1. DO NOT SCALE FROM DRAWING 2. REMOVE ALL SHARP EDGES, R.02 MAX. 3. ALL MACHINING FLUIDS SHALL BE WATER SOLUBLE AND FREE OF SULFUR, CHLORINE AND SILICONE, SUCH AS CINCINNATI MILACRON'S CIMTECH 410 (STAINLESS STEEL)		TOLERANCES: .XX ± 0.01 .XXX ± 0.005 ANGULAR ± 0.5°		SYSTEM <b>ADVANCED LIGO</b>													
④ SCRIBE, ENGRAVE OR MECHANICALLY STAMP DRAWING (NO INKS OR DYES) PART NUMBER, REVISION ON NOTED SURFACE OF PART FOLLOWED ON THE NEXT LINE WITH A THREE DIGIT SERIAL NUMBER. SERIAL NUMBERS START AT 001 FOR THE FIRST ARTICLE AND PROCEED CONSECUTIVELY. USE .12" HIGH CHARACTERS, UNLESS THE SIZE OF THE PART DICTATES SMALL CHARACTERS. A VIBRATORY TOOL MAY BE USED. EXAMPLE: D050035-A S/N 001		MATERIAL <b>6061-T6-AL</b>		SUB-SYSTEM <b>SUS</b>													
		FINISH <b>32 μ inch</b>		NEXT ASSY <b>C-Ptype ETM TOP MASS</b>													
		<table border="1"> <thead> <tr> <th></th> <th>NAME</th> <th>DATE</th> </tr> </thead> <tbody> <tr> <td>DRAWN</td> <td>M.Perreur-Lloyd</td> <td>07JUL04</td> </tr> <tr> <td>CHECKED</td> <td>C.Torrie</td> <td>30SEP04</td> </tr> <tr> <td>APPROVED</td> <td></td> <td></td> </tr> </tbody> </table>			NAME	DATE	DRAWN	M.Perreur-Lloyd	07JUL04	CHECKED	C.Torrie	30SEP04

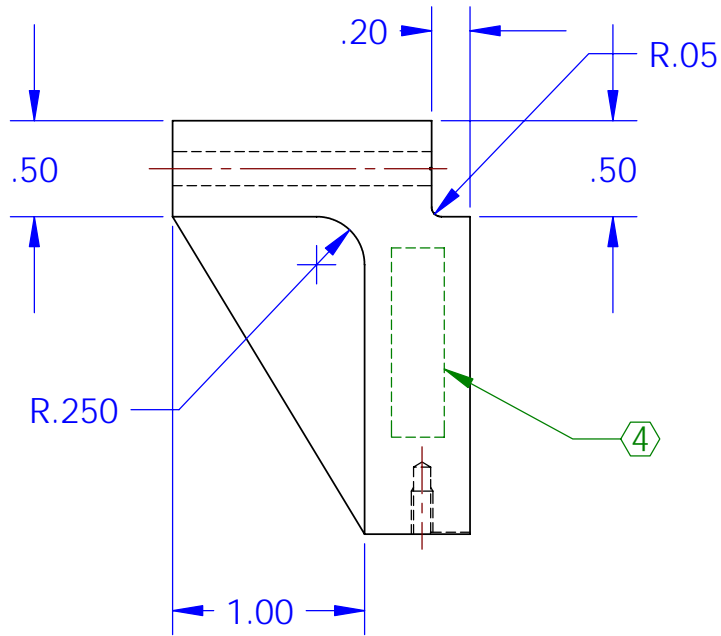
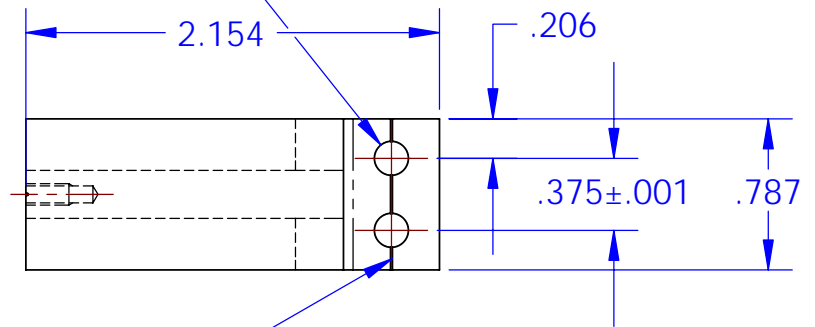
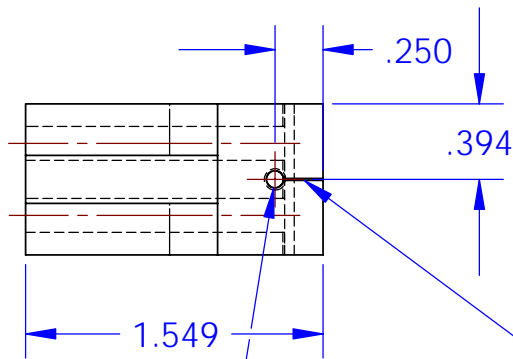
ADD VENT GROOVES  
.02 WIDE BY .02 DEEP
